Catherine Field Primary School Mod 2 Additional Information – 19th November 2020

SECTION 4.55(1A) MODIFICATION APPLICATION, NEW CATHERINE FIELD PUBLIC PRIMARY SCHOOL (SSD 9477 – Mod 2) – ADDITIONAL INFORMATION

We refer to the Department of Planning, Infrastructure and Environment (DPIE) request for additional information dated 10th November 2020 relating to matters raised by Camden Council. The following information re-states the matters (in *italics*) and provides a response to each.

PERUMAL PEDAVOLI ARCHITECTS
DRAWING NAME
CATHERINE FIELD PS
NEW HIGH QUALITY CLASSROOMS
LANDSCAPE: TEMPORARY CAR
PARK ACCESS

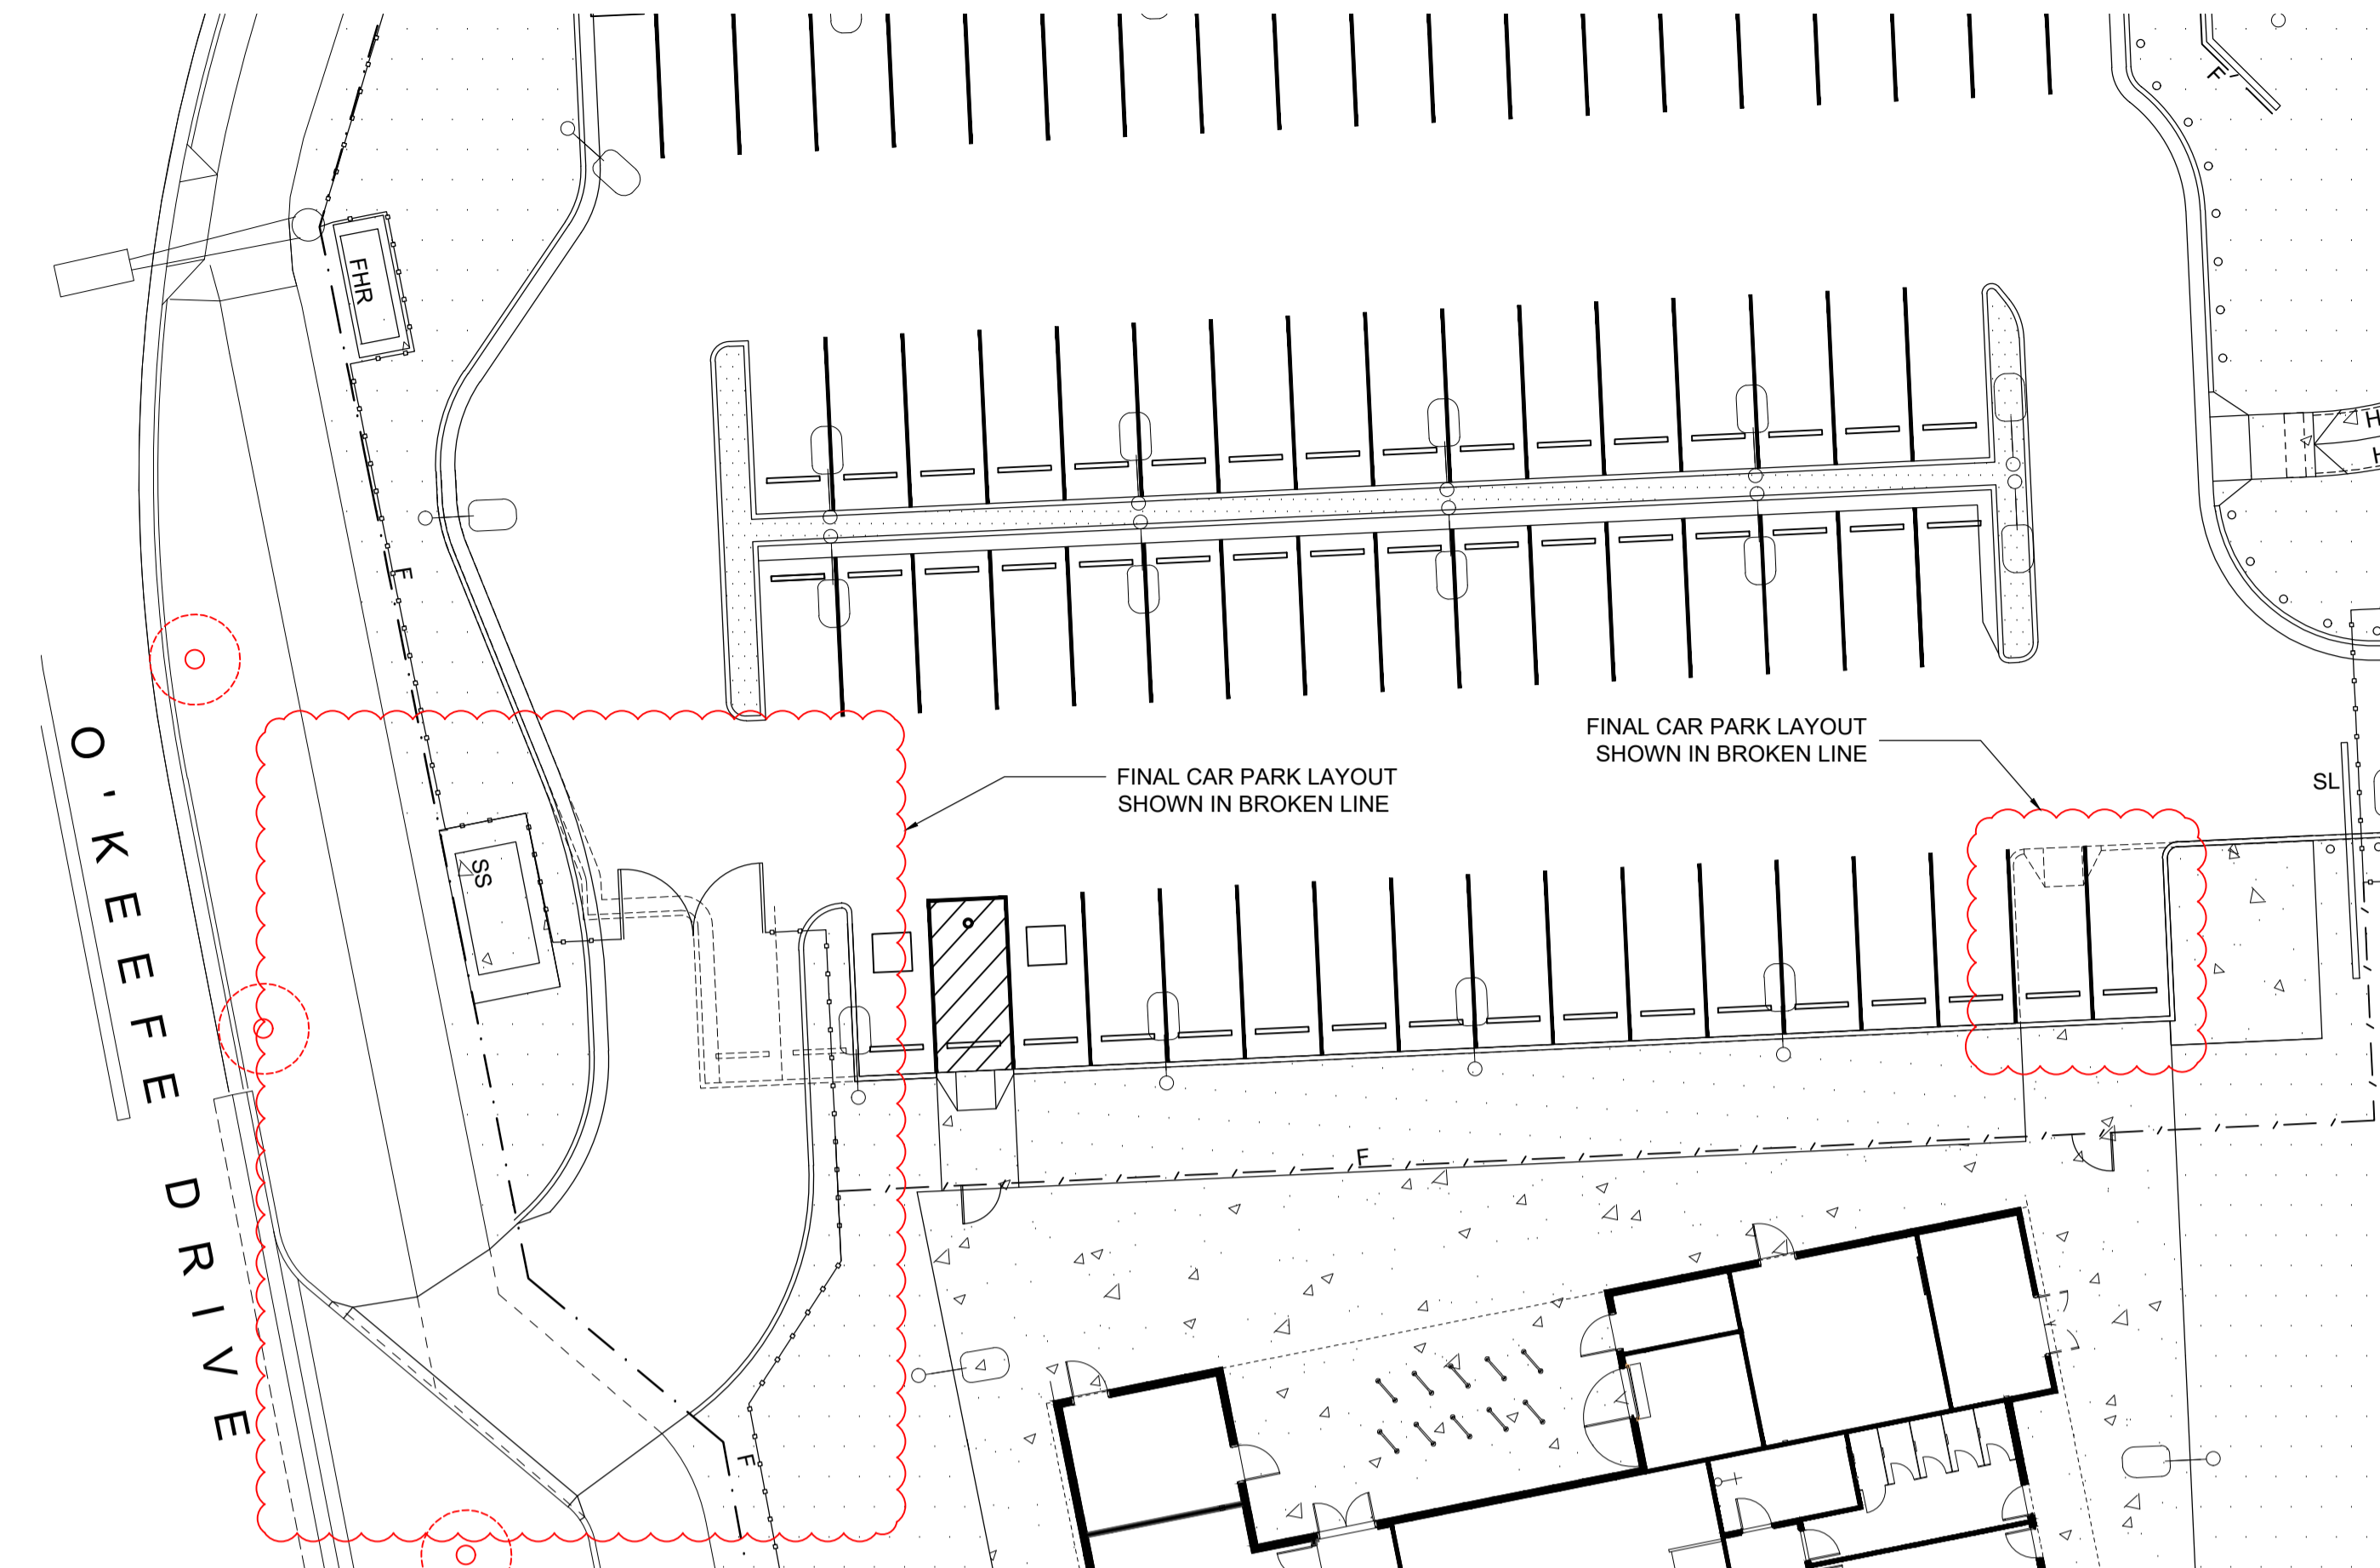
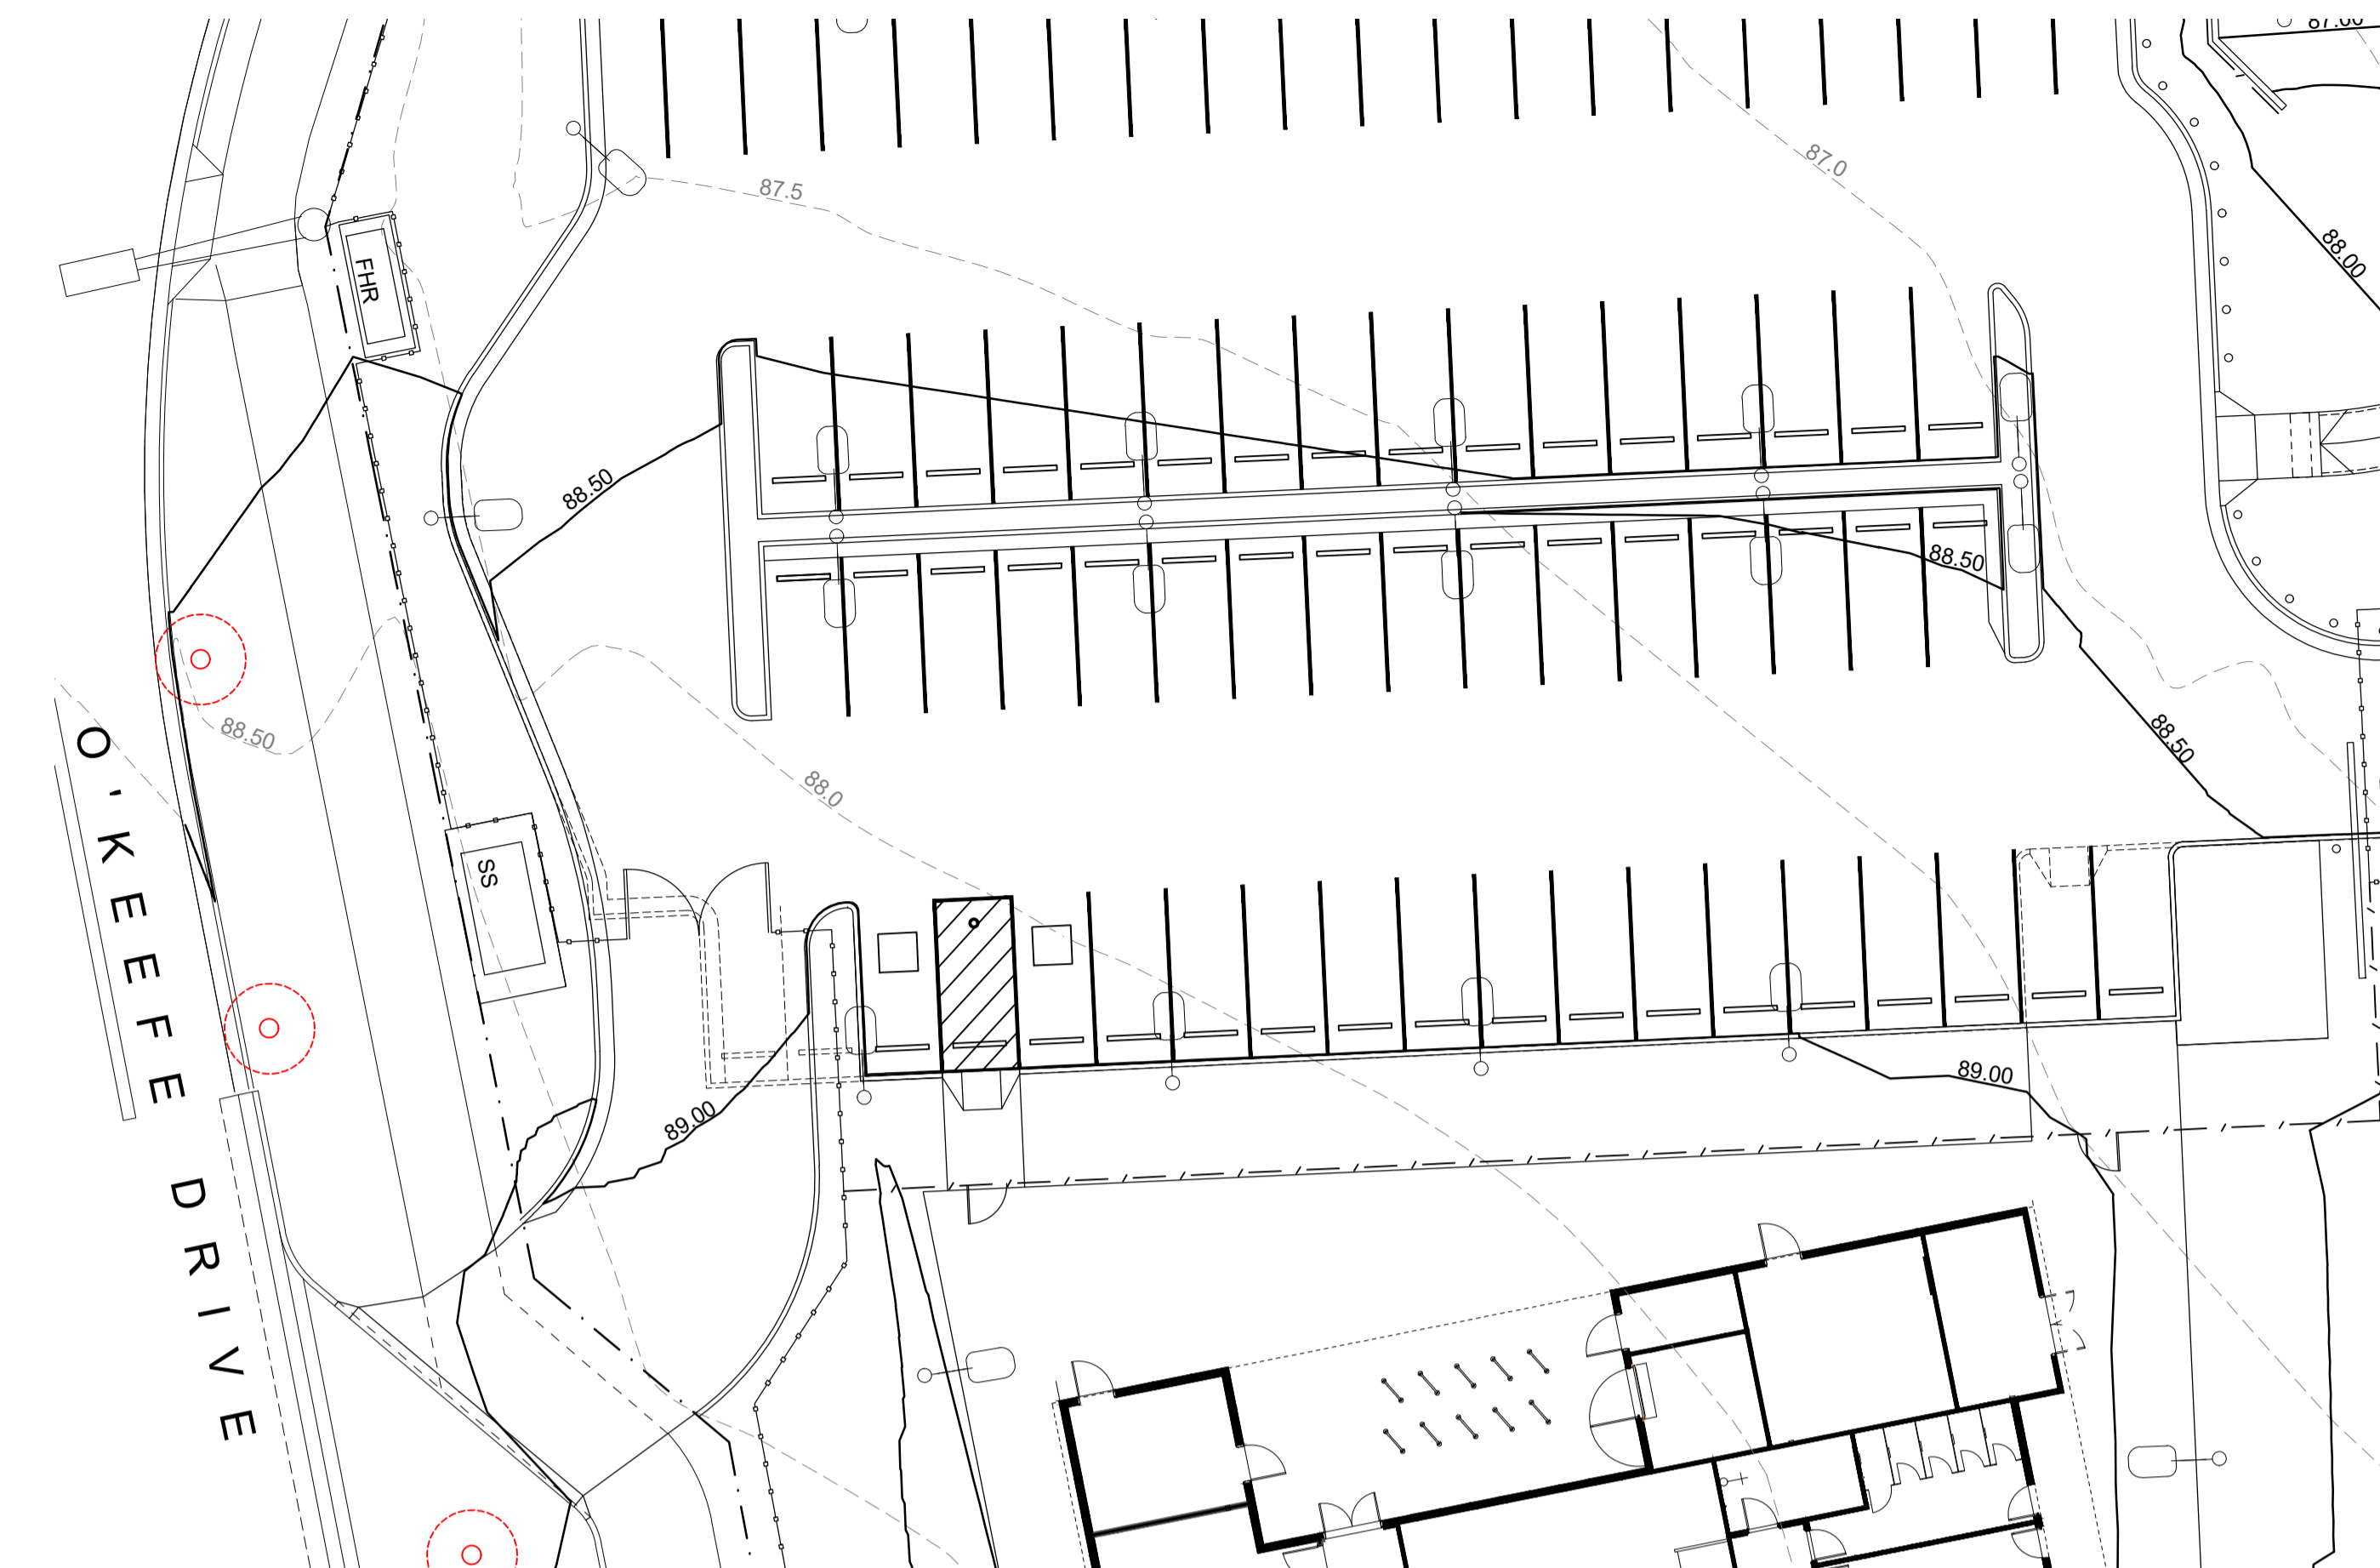
2. *Sightlines at the interim access shall be assessed – the driveway is angled and setback, also it's not clear if trees will be planted adjacent to the driveway*

7. *The landscape plans submitted with the application show the removal of all street trees along O'Keefe Drive and no street trees along the southern perimeter road. There appears to be ample opportunity to plant street trees in the unencumbered areas of these road verges. Street trees should be avoided near the entrance and exit of the kiss and drop / interim car park to avoid blocking sight lines.*

Street trees will not be planted either side of the connection point of the temporary access with the bus and special needs student drop off area. Mass planting will occur within the school site including along the fence line of O'Keefe Drive. Sufficient sightlines will be afforded to vehicles entering and exiting the car park.

As mentioned on page 1 street trees will not be planted either side of the connection point of the temporary access with the bus and special needs student drop off area. The depth of the bus and special needs student drop off area and the Council request for 3.5m wide footpaths in the area eliminates the ability to provide street trees in this location. Mass planting will occur within the school site including along the fence line of O'Keefe Drive. It is also noted that once the interim access is removed two street trees could be reinstated at the northern end of O'Keefe Drive.
